ENCLOSURE 3

VOGTLE ELECTRIC GENERATING PLANT
REQUEST FOR TECHNICAL SPECIFICATION CHANGES
RESPONSE TO GENERIC LETTER 89-01
RADIOLOGICAL EFFLUENT TECHNICAL SPECIFICATION CHANGES

PROPOSED TECHNICAL SPECIFICATION CHANGES

TABLE 3.3-10

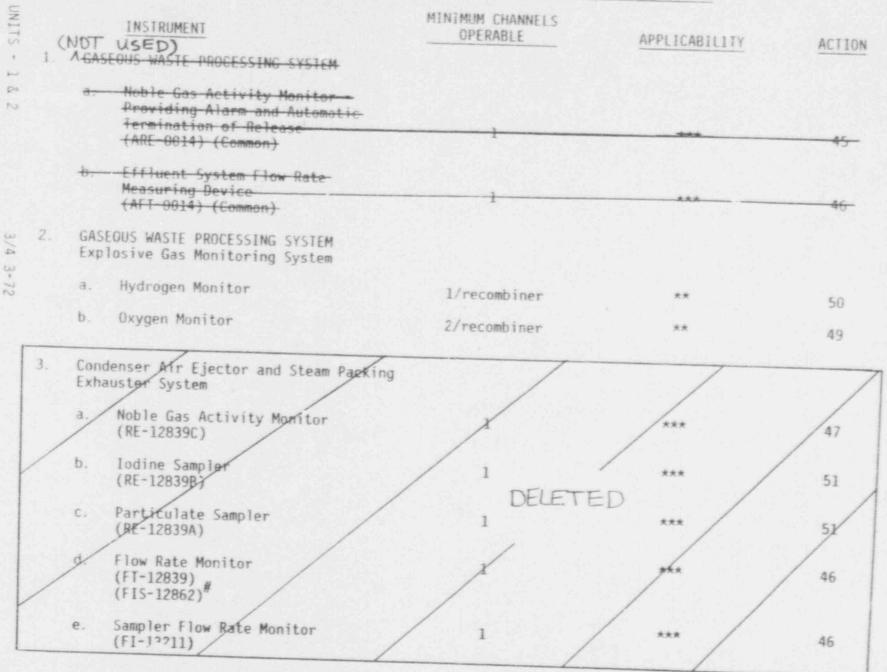
explosive 995 3.3.3.10 The radioactive assess effluent Amonitoring instrumentation channels shown in Table 3.3-10 shall be OPERABLE with their harm/Trip Setpoints set to ensure that the limits of Specifications 3.11.2.1a and 3.11.2.5 are not exceeded. The Alarm/Trip Setpoints of these channels meeting Specification 3.11.2.1a shall be determined and adjusted in accordance with the methodology and parameters in the ODCM.

an explosive gas With a radioactive assess effluent/monitoring instrumentation channel Alarm/Trip Setpoint less conservative than required by the above specification, immediately suspend the release of radioactive gaseous effluents monitored by the affected channel, or declare the channel inoperable and take the ACTION shown in Table 3.3-10. explosive gas

EXPLOSIVE GAS A RAGIOACTIVE GASEOUS EFFLUENT MONITORING INSTRUMENTATION
